ACCESSION NBR: 8412010013 DOC. DATE: 84/11/20 NOTARIZED: NO DOCKET #
 FACIL: 50-410 Nine Mile Point Nuclear Station, Unit 2, Niagara Moho 05000410
 AUTH. NAME AUTHOR AFFILIATION
 MANGAN, C.V. Niagara Mohawk Power Corp.
 RECIP. NAME RECIPIENT AFFILIATION
 SCHWENCER, A. Licensing Branch 2

SUBJECT: Forwards marked-up Tech Specs. Tech Specs, representing util
 policy decision to utilize 24 month (from startup to
 startup) refueling outages.

November 20, 1984
(NMP2L 0253)

Re: Nine Mile Point Unit 2
Docket No. 50-410

FIGURE 3.4.6.1-1a MINIMUM REACTOR VESSEL TEMPERATURE FOR
PRESSURIZATION DURING HYDROSTATIC TESTING
(REACTOR CORE NOT CRITICAL)

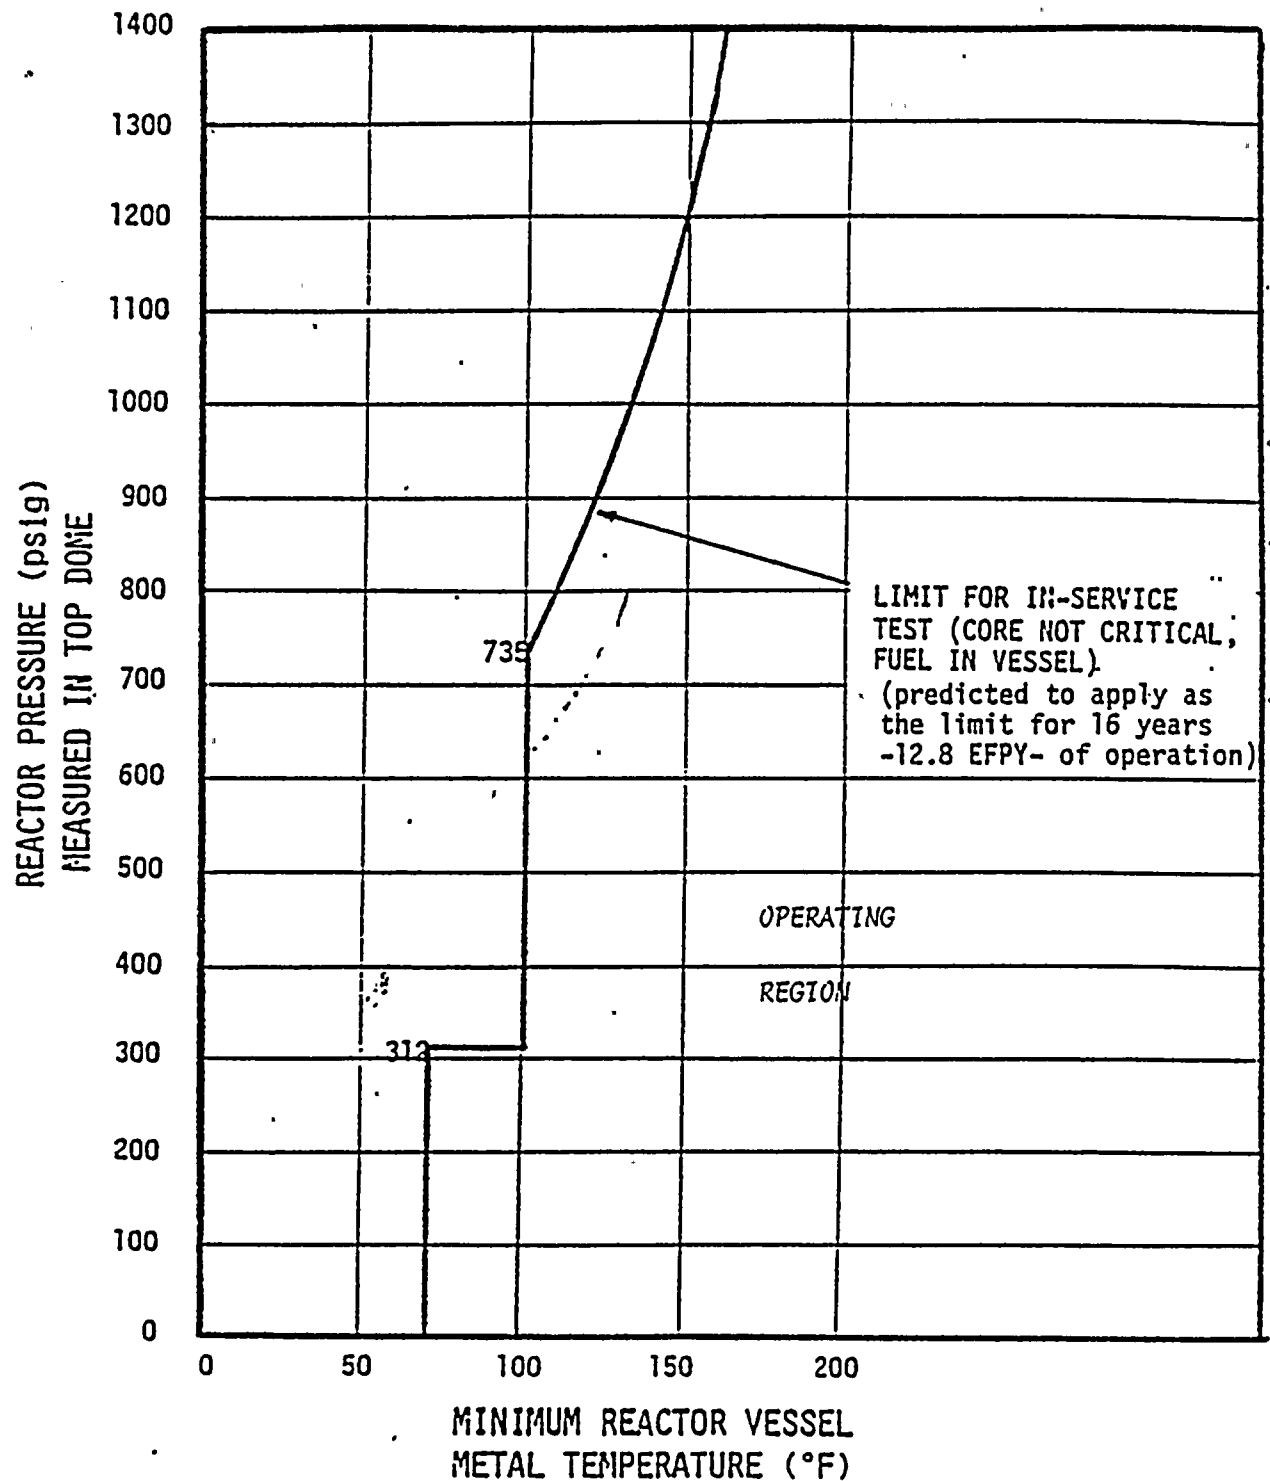
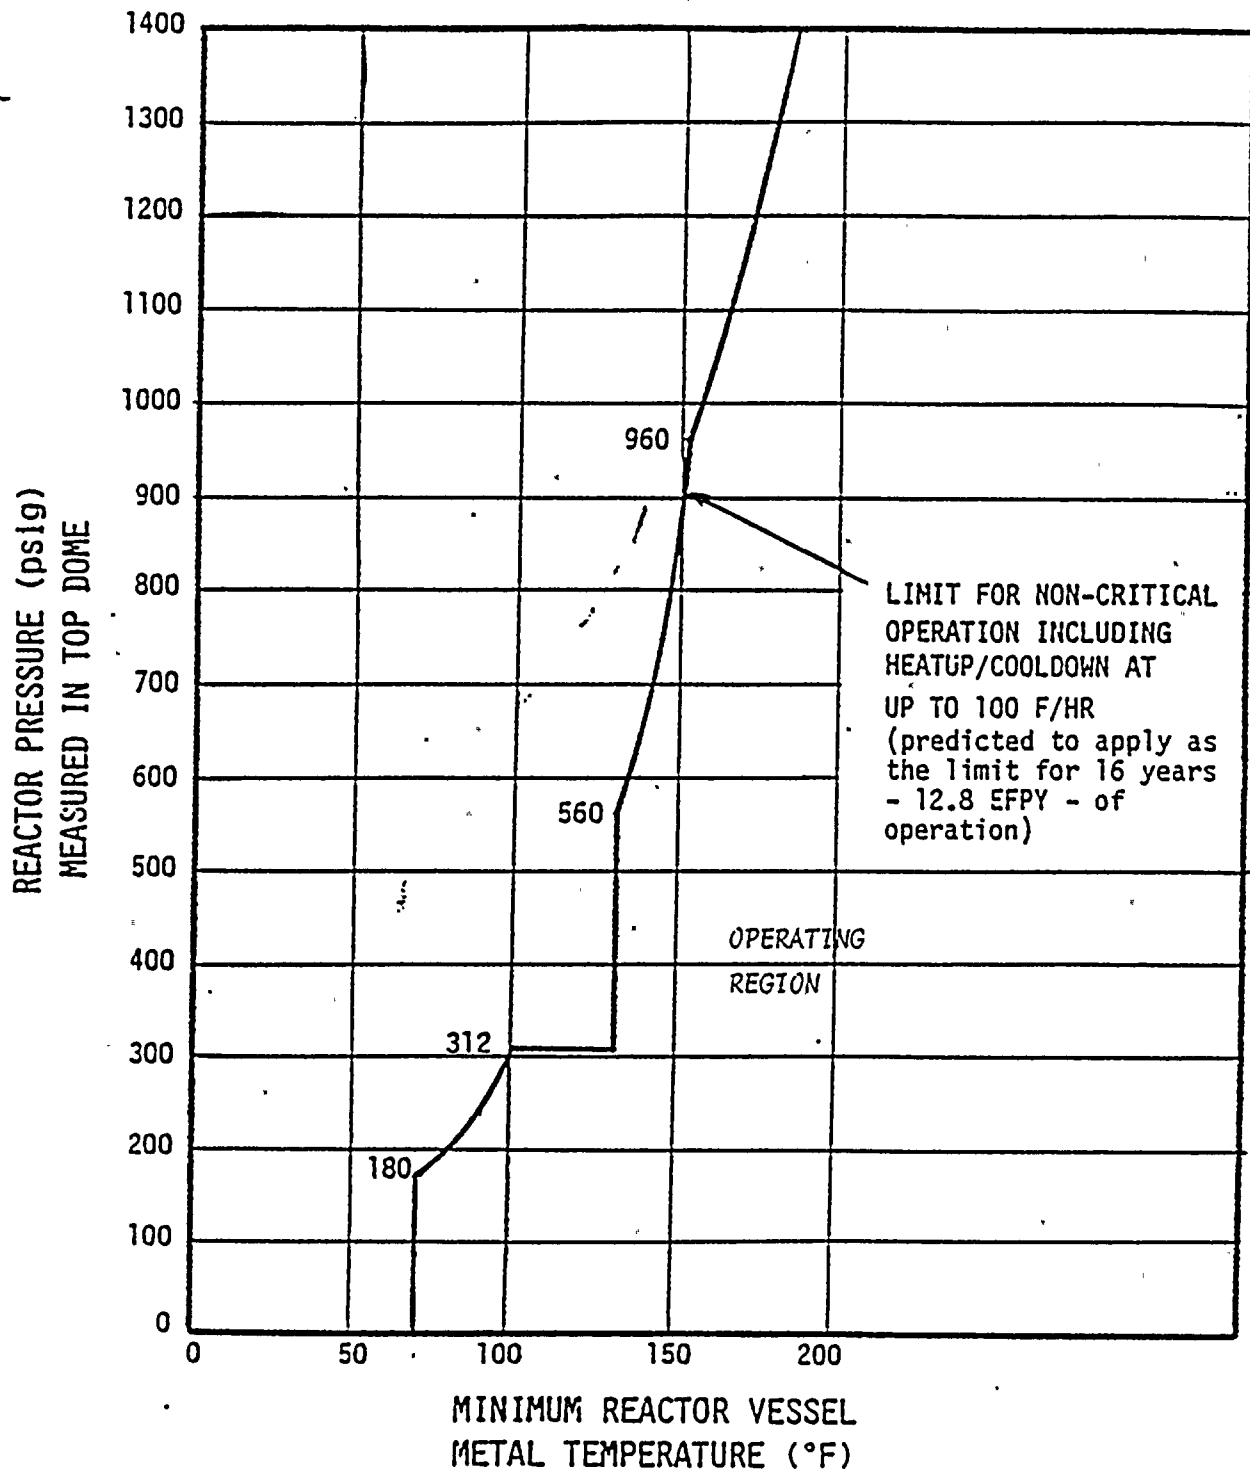
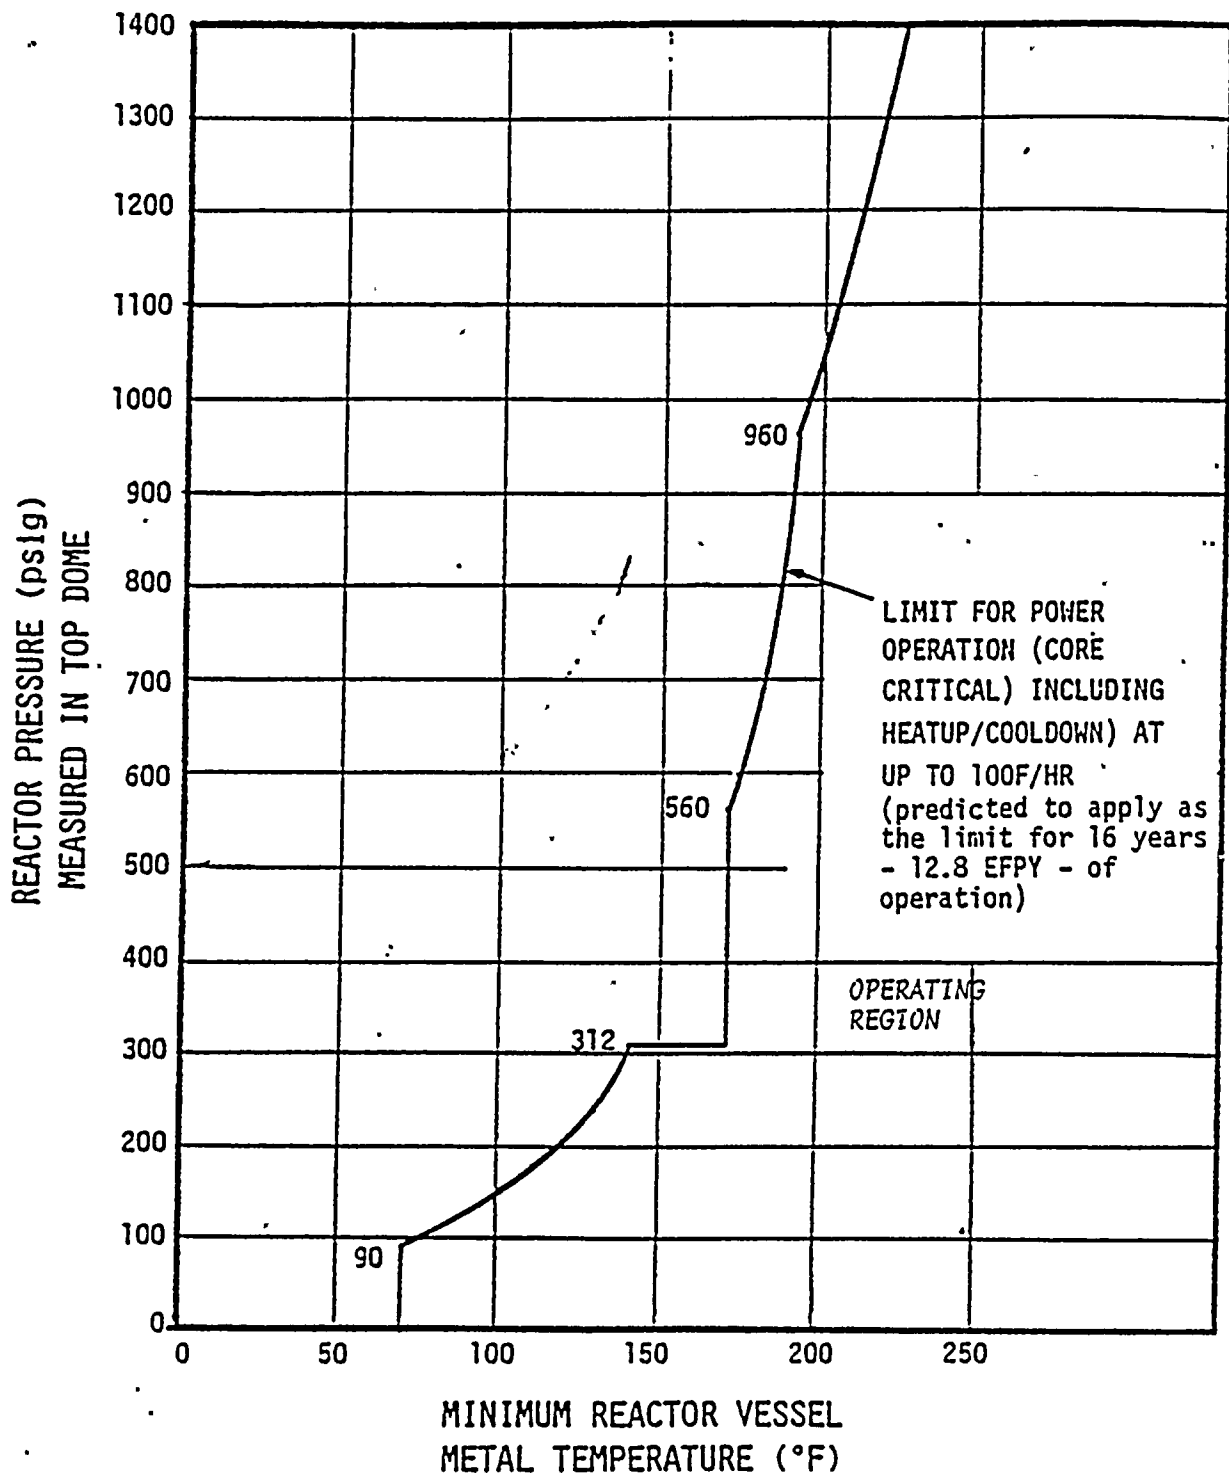
4.4.6.1.1 During system heatup, cooldown and inservice leak and hydrostatic testing operations, the reactor ~~coolant system temperature and pressure~~ shall be determined to be within the above required heatup and cooldown limits and to the right of the limit lines of Figure 3.4.6.1-1 curves A and A⁺ or B and B⁺ as applicable, at least once per 30 minutes. ^{steam space} vessel pressure and metal temperature of the reactor vessel flange surfaces, bottom outside surface and bottom head inside surface, as measured by the bottom head drain temperature shall be determined to be to the right of the region defined by Figures 3.4.6.1-1a, b, c at least once per 30 minutes.

4.4.6.1.2 ~~The reactor coolant system temperature and pressure shall be determined to be to the right of the criticality limit line of Figure 3.4.6.1-1 curves C and C' within 15 minutes prior to the withdrawal of control rods to bring the reactor to criticality and at least once per 30 minutes during system heatup.~~

4.4.6.1.3 ~~The reactor vessel material specimens shall be removed and examined to determine reactor pressure vessel fluence as a function of time and THERMAL POWER as required by 10 CFR 50, Appendix H in accordance with the schedule in Table 4.4.6.1.3-1. The results of these fluence determinations shall be used to update the curves of Figure 3.4.6.1-1.~~

4.4.6.1.4 The reactor flux wire specimens shall be removed at the first normal outage after 1 year and before the end of 2 years of initial operation and examined to determine reactor pressure vessel fluence as a function of time and power level and used to modify the Figure B3/4.4.6-1. The results of these fluence determinations, in conjunction with Bases Figure B3/4.4.6.2, shall be used to adjust, if needed, the curves of Figure 3.4.6.1-1.

Figure B.3/4.4.6-2

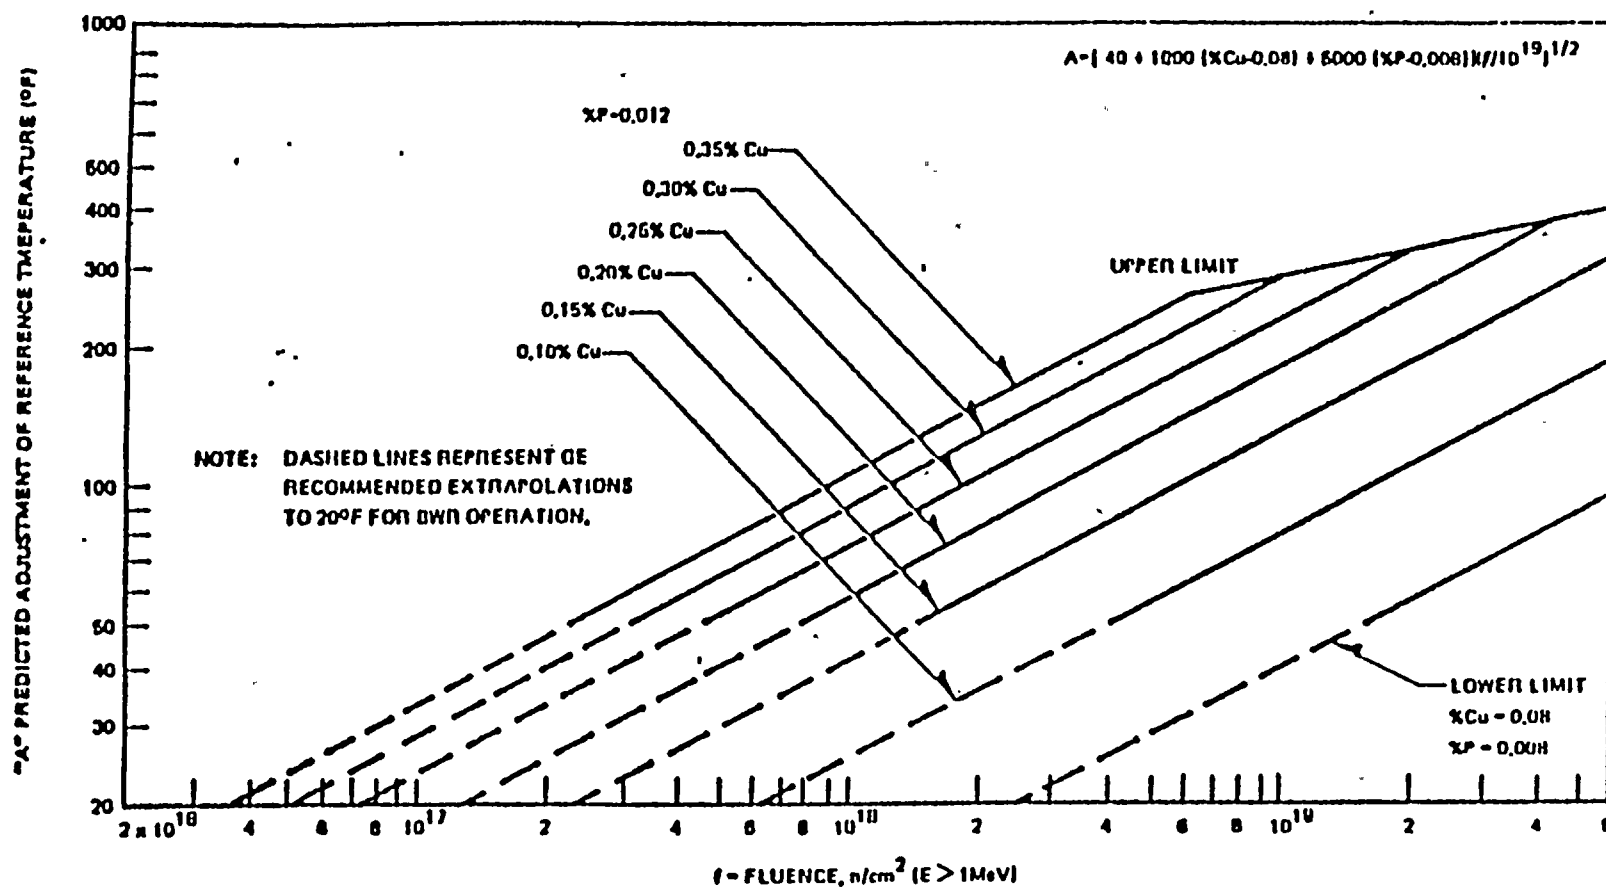
AT of RATED THERMAL POWER AND 90% AVAILABILITY
typical figure; to be modified per Specification 4.4.6.1.4
